PLANNING AND ZONING COMMISSION
REGULAR MEETING
JUNE 11, 2026 – 5:30 P.M.
CITY HALL-COUNCIL CHAMBERS
415 WEST UNIVERSITY DRIVE
EDINBURG, TEXAS 78539

AGENDA

City of Edinburg
PLANNING & ZONING COMMISSION
June 11, 2026

PLANNING & ZONING COMMISSION
Regular Meeting: 06/11/2026

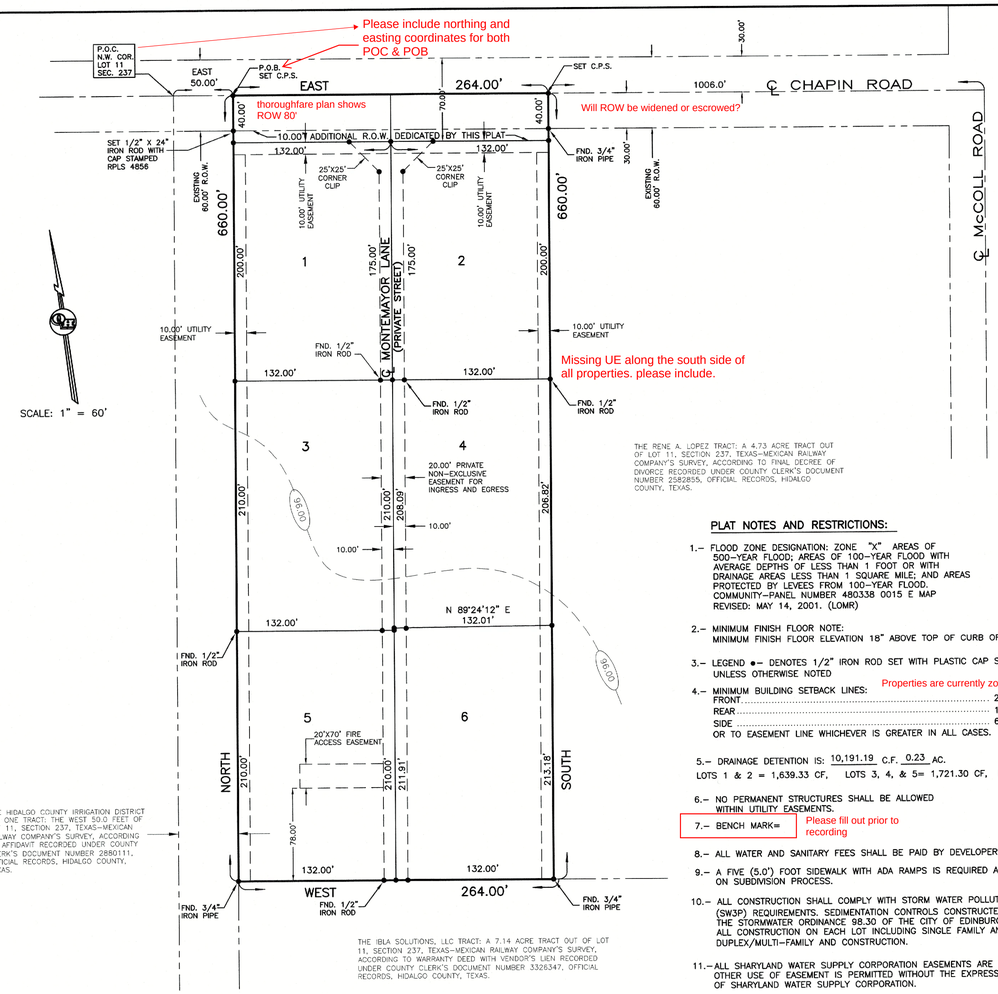
8.– ALL WATER AND SANITARY FEES SHALL BE PAID BY DEVELOPER. Remove plat note 8

Plat Note Requirement: Pursuant to applicable fire safety regulations, the installation of additional fire hydrants, fire department access road(s), fire rated construction, and other fire protection equipment may be mandated during the Site Plan or Building Permit process.

Provide Sharyland Waterline Access Agreement

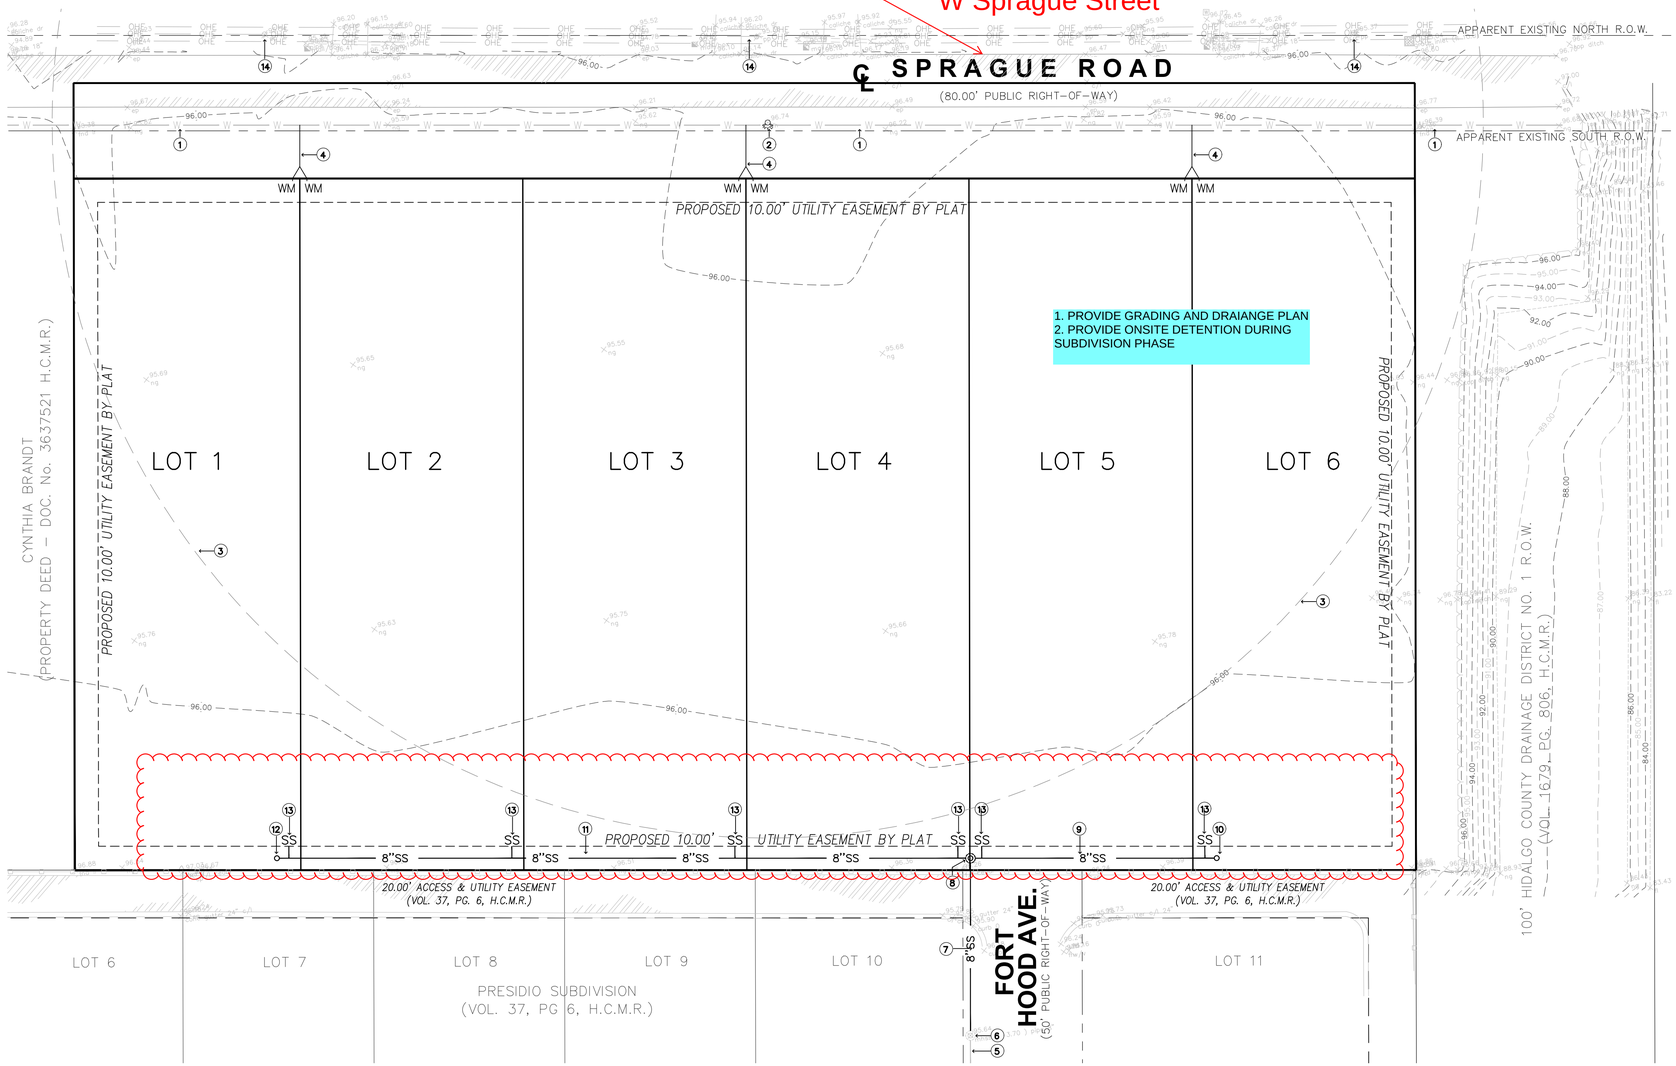
correct on each page please

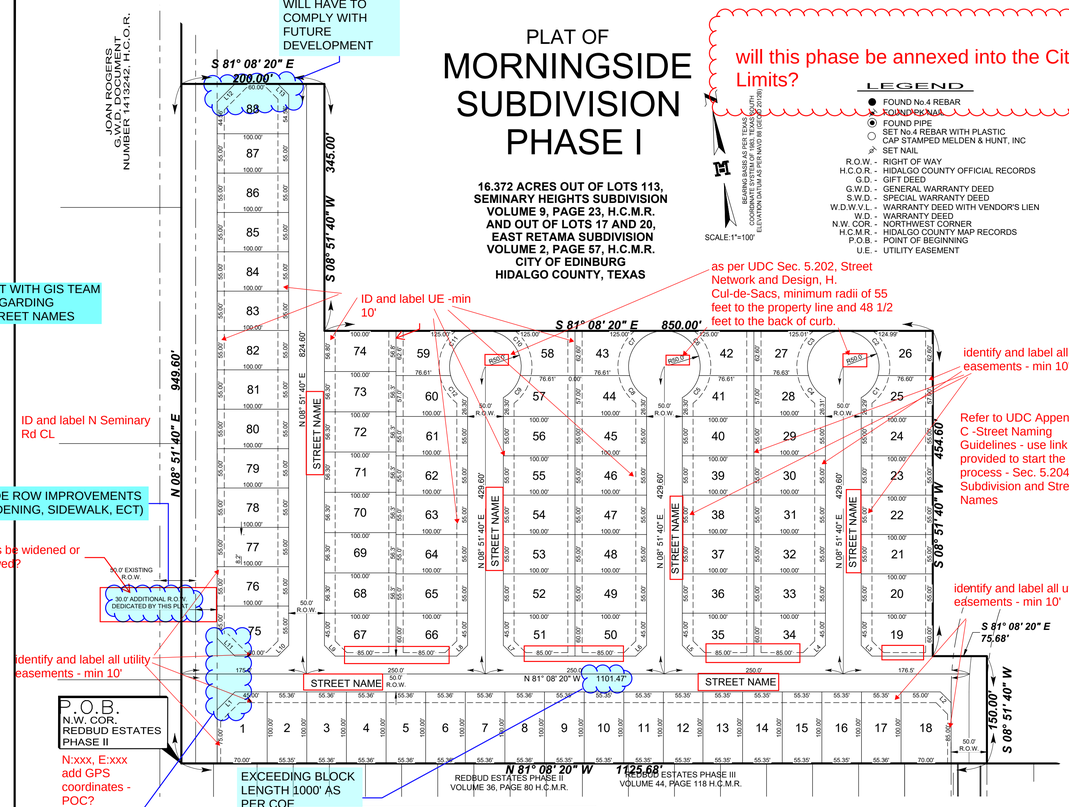
CORNER CLIPS MUST COMPLY WITH 2021 COE STANDARDS MANUAL FOR A MINOR ARTERIAL X MINOR RESIDENTIAL

EXCEEDING BLOCK LENGTH 1000' AS PER COE STANDARDS
